## Application of time domain induced polarization to the mapping of lithotypes in a landfill site.

Reply to referees, by Gazoty et al., March 16<sup>th</sup>, 2012.

Cross-section of the contaminated plume. Concentration levels refer to the total sum of chlorinated compounds.

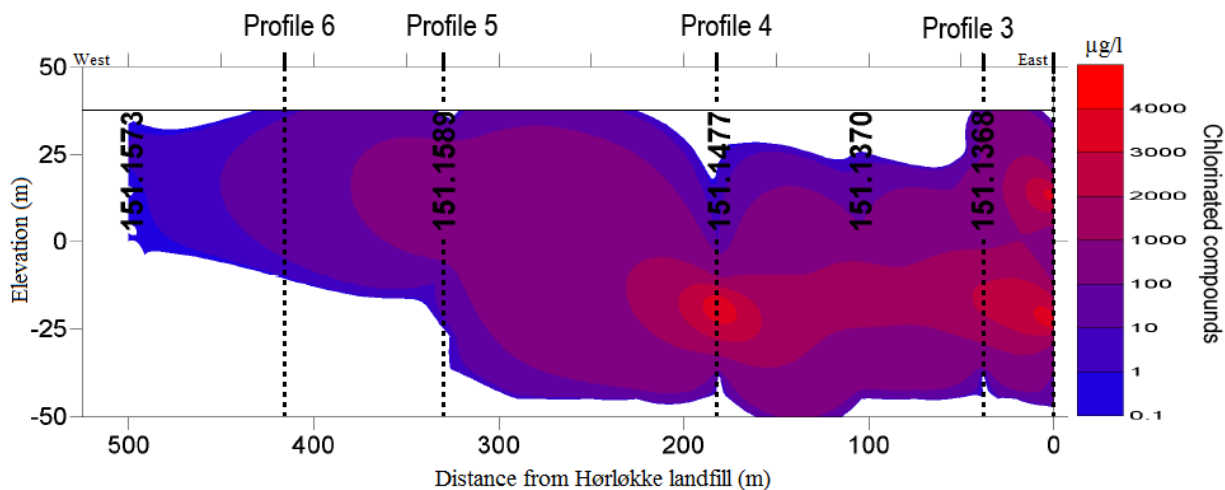
*How was the contamination (page 987) characterized in the landfill itself and in the plume? By fluid sampling in the logged boreholes (page 990) and taking into account the log data?*

*No analysis on contaminant concentrations - No discussion on plume localization: in the abstract, introduction, and at fig.11, authors mention a contaminant plume (drawn on fig 11 sketch) but we don't know how this plume was found (what kind of anomaly is created by the plume?).*

**A.G. et al.:** After careful reading, we agree on the fact that more explanations could be brought to the plume description. As inferred from Referee #1, the contamination plume is characterized by water samples thanks to a numerous number of deep boreholes present within and outside the landfill area. These boreholes allowed the collection of water samples up to 60-70 m depth, and by interpolating these results, it was possible to precise the lateral extent of the plume as well as its depth. Thus, a map and a cross-section of the contamination plume could be made on the basis of boreholes where a significant content of chlorinated compounds was encountered (Sønderjyllands Amt, 2007). In order to improve and clarify the manuscript, we propose to add this explanation in page 987, line 13. A figure showing the inferred shape and extent of the plume could also be added in complement, just after Figure 1 (see below).

**A.G. et al.:** We partially answered this question in Part A, thanks to Referee 1. We agreed to include the explanations above mentioned as well as a figure showing the extent of the plume West from the landfill with the concentration levels of chlorinated compounds. In the manuscript, we specified that the plume yielded to high concentrations of hydrocarbons, iron and inorganic compounds, as well as a small amount of percolating chlorinated compounds, within the landfill (P 987 lines 15-18). Within the plume, the contamination is composed of a high concentration of volatile chlorinated compounds and inorganic parameters (potassium, sodium, calcium, chloride, etc.). Furthermore, the chemical analysis revealed that the chlorinated compounds found from the boreholes are trichloromethane, 1, 1, 1-trichloroethane, trichloroethylene, Cis-1, 2-dichloroethylene and 1,1-dichloroethane.

*Inverted sections for Profile 4 (see map in Fig. 1) with superimposed boreholes. (a) Resistivity section. (b) Chargeability  $m_0$ . (c) Tau parameter. (d) C parameter.*

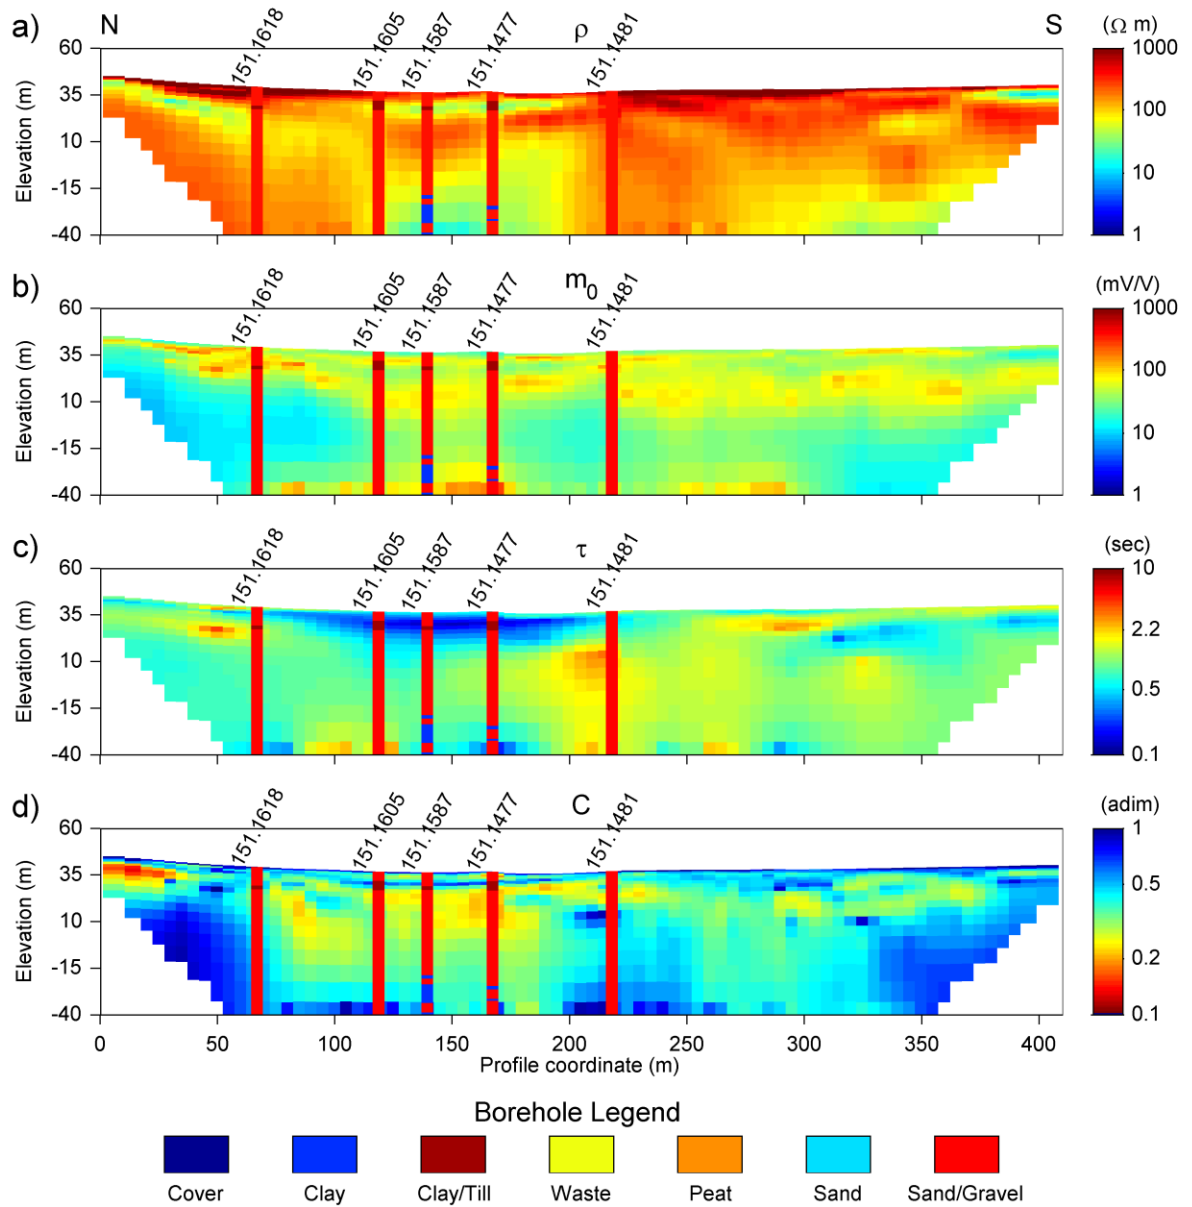
*There is an introduction on Cole-Cole model in time domain, multi-windows IP measurements, also a chapter on inversion of DC-IP data (pp989-990). But finally there is just an analysis of M0 chargeability (is it calculated after inversion of chargeability curves?). Give more explanations why tau and c are not relevant.*

*Nevertheless, I have seen recent communications from the same authors explaining that tau and c improve lithology discrimination, data interpretation (e.g. at the Second International Workshop on Induced Polarization). – If tau and c add no information, maybe the Cole-Cole model is not appropriate. Make a discussion.*

**A.G. et al.:** Actually the M0 parameter is one of the direct output from the inversion, where the four Cole-Cole parameters are retrieved for each layer; these Cole-Cole parameters are the resistivity (Ohm m), the chargeability M0 (mV/V) which is the chargeability taken at time  $t=0$ , tau (s), and c (dimensionless). It is true that the manuscript only shows results for the M0 parameter, because it is the only one for which a straightforward correlation with the lithology, the waste content and borehole information can be made. Indeed, M0 tells you how polarizable the medium is, and whether there is a signature in chargeability or not. Parameters tau and c are also relevant and provide significant information at the pore scale, and can be linked somehow with hydrogeological parameters as hydraulic conductivity, but their use involves a further modeling and analysis, which is beyond the scope of this study.

We propose anyway to replace the current Figure 8 by the figure below, where parameters tau and C have been added. From this figure, it seems that high C fits with the clay layer, in agreement with borehole information (borehole numbers 151.1605, 151.1587). The parameter tau shows some general trends, such as a small magnitude within 50-200 m laterally, where the stream is located, and an increase of magnitude with depth beyond 20 m. In the Hørsløkke case study, we do not have enough information to link these trends with petrophysical properties, whereas the interpretation of M0 in terms of landfill location and lithological discrimination is straightforward. The observed lateral variations of Tau are probably not related to an unsuitable model, and would most likely appear with another model such as the Davidson-Cole one. The sensitivity analysis shows that the main features are reliable, but can not be more interpreted at this state of knowledge.

Gamma logs (black) in comparison with 1-D models extracted from surface measurements.  
**(a)** Chargeability  $M_0$ . **(b)** Resistivity.

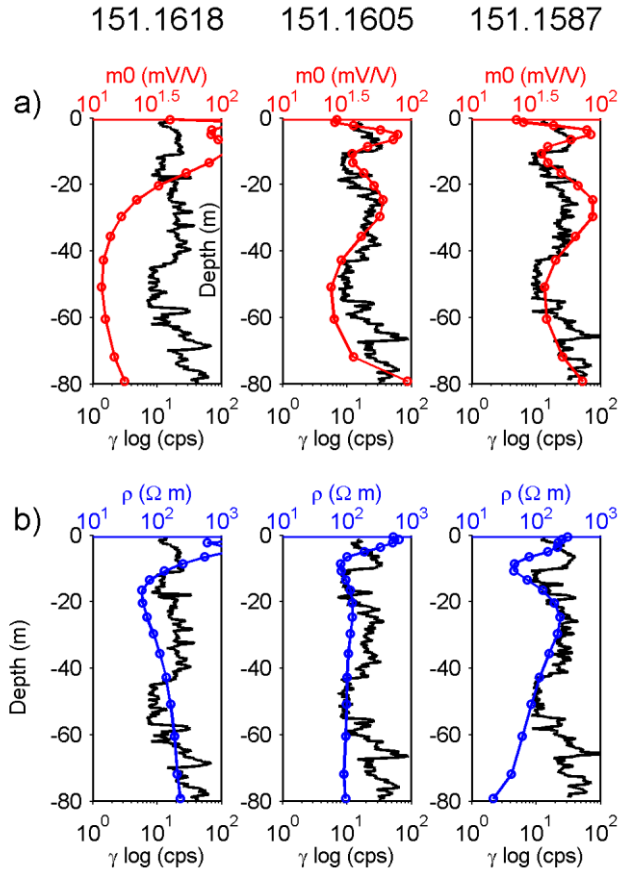
*I didn't understand why loggings from 151-1477 well are so noisy. If you have no confidence with this logging, don't show it!*

**A.G. et al.**: As mentioned in the manuscript, we know that borehole 151-1477 was not drilled in the same conditions as other boreholes (“gamma log experiment carried out many years after the drilling, with the casing inside”), this is why we do not have any confidence in it. We agree with the Referee that showing loggings from 151-1477 will add some confusion, this is why we chose to remove it from the study and from Figure 9 (see below) where it initially appeared.
